Subject:
Former Plainwell Impoundment 2010 Bank Conditions Monitoring Report
Allied Paper, Inc./Portage Creek/Kalamazoo River Superfund Site

A draft copy of the Monitoring Report dated January 26, 2011 was submitted to USEPA in February 2011. In a letter dated April 8, 2011, USEPA submitted comments on the draft Monitoring Report. Those comments have been addressed in the enclosed final Monitoring Report. A summary of the responses to USEPA comments is included below.

**Former Plainwell Impoundment
2010 Bank Conditions Monitoring
Report**

**MONITORING TRANSECT
CROSS SECTIONS - T-1 AND T-2**

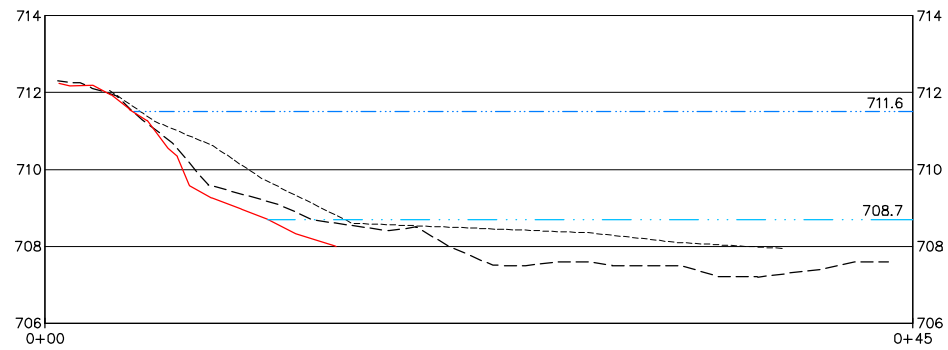
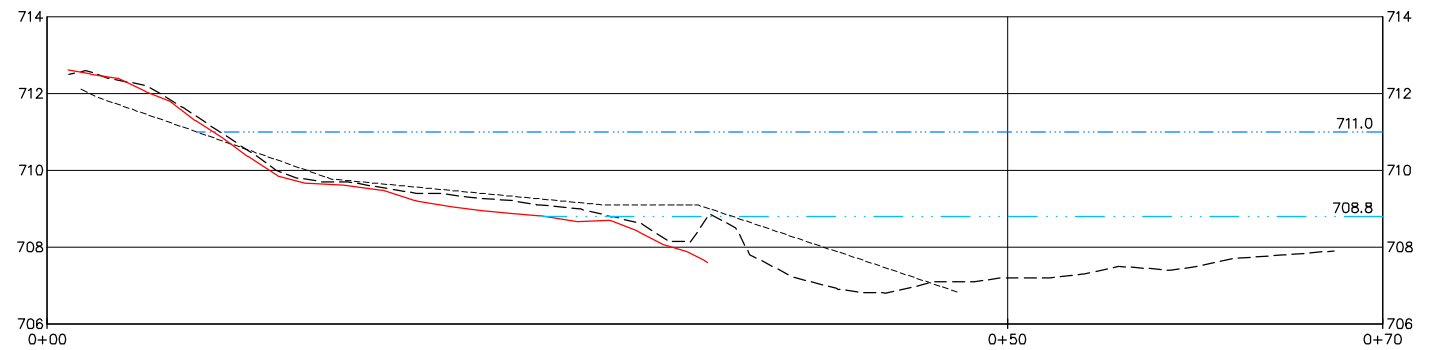
USEPA Comment 2: Section 4.2, Comparison of Surveyed Banks: Some of the text descriptions in this section appear to be inconsistent with the bank profiles. Some of the bank profiles show erosion between the 2009 and 2010 monitoring events and needs to be more clearly indicated in the text description (e.g. T-2S, T-

4N, T-4S, T-6S). The issue of the truncated profiles plays into limiting the utility of the description.

ARCADIS Response: The report will be revised to make the bank descriptions consistent with the bank profiles and explain which transects did not evaluate the bank toe. Individual bank descriptions will be revised as follows:

- T-2S – This transect is located on the south bank in Removal Area 3B. It appears to be similar to its design with a stable slope to a point between the prism-out 2-year and median water elevations. ~~and some possible sediment buildup on the bank and at the toe of the bank.~~ Below this point, some toe erosion can be noted. ~~There is no apparent change in the geometry of the restored bank at this location from 2009 to 2010.~~ This bank is currently characterized as stable.
